**Site-Specific Sampling and Analysis Plan  
Remedial Investigation at TNT Area B  
Former Plum Brook Ordnance Works  
Sandusky, Ohio**

**RESPONSE TO OEPA TECHNICAL REVIEW COMMENTS  
DRAFT WORK PLANS FOR THE TNT AREA B RI/FS  
PLUM BROOK ORDNANCE WORKS, SANDUSKY, OHIO**

**RESPONSES TO TECHNICAL REVIEW COMMENTS**  
**DRAFT SITE-SPECIFIC SAMPLING AND ANALYSIS PLAN (SSAP) AND**  
**SITE-SPECIFIC SAFETY AND HEALTH PLAN (SSHP), RI/FS OF TNT AREA B**  
**PLUM BROOK ORDNANCE WORKS, SANDUSKY, OHIO**

**FIGURE IX-2**  
**ROUTE FROM TNT AREA B TO US**  
**HIGHWAY 250**

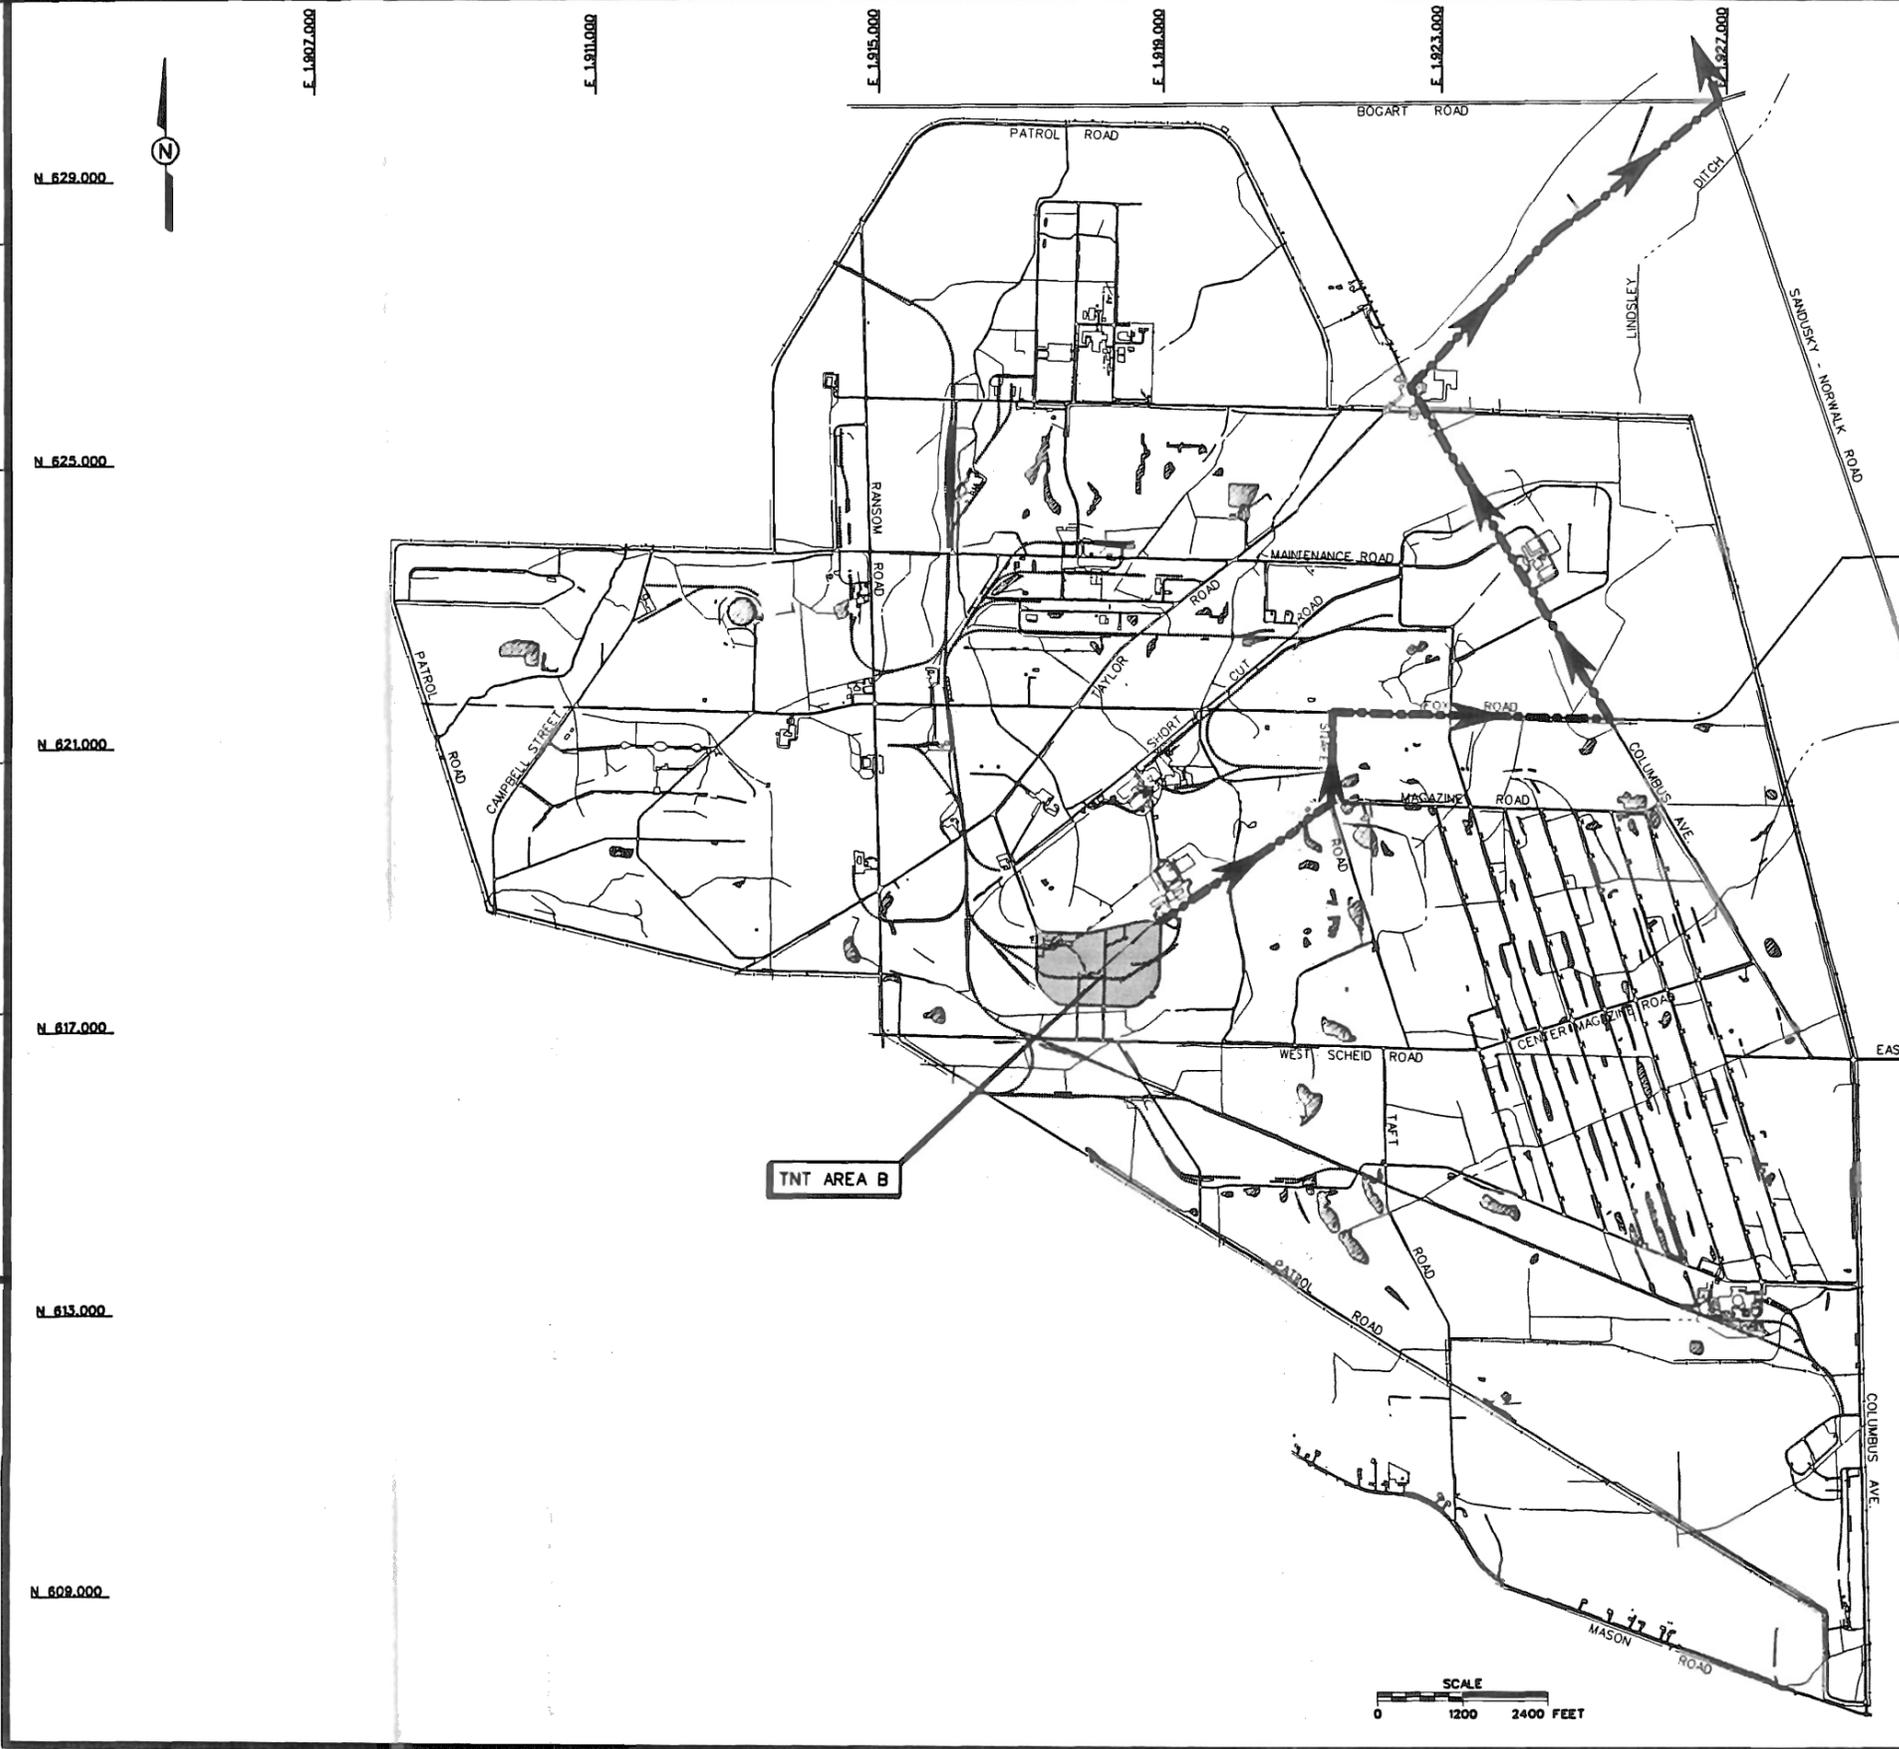
**Comment 1.** [Part IX.2.0, Site Characterization and Analysis, Page IX-2, Section IX.2.2 General Site Information] Please include a map of the referenced TNT Area B.

**Comment 3.** [Part IX.2.0, Site Characterization and Analysis, Section IX.2.2 General Site Information] Due to the size of the Plum Brook Ordnance Works facility please include a map identifying the most direct route on the facility from the TNT Area B to the Main Gate.

*Response: A new figure (Figure LX-2) has been added of TNT Area B.*

*Response: The requested information is included on Figure LX-2.*
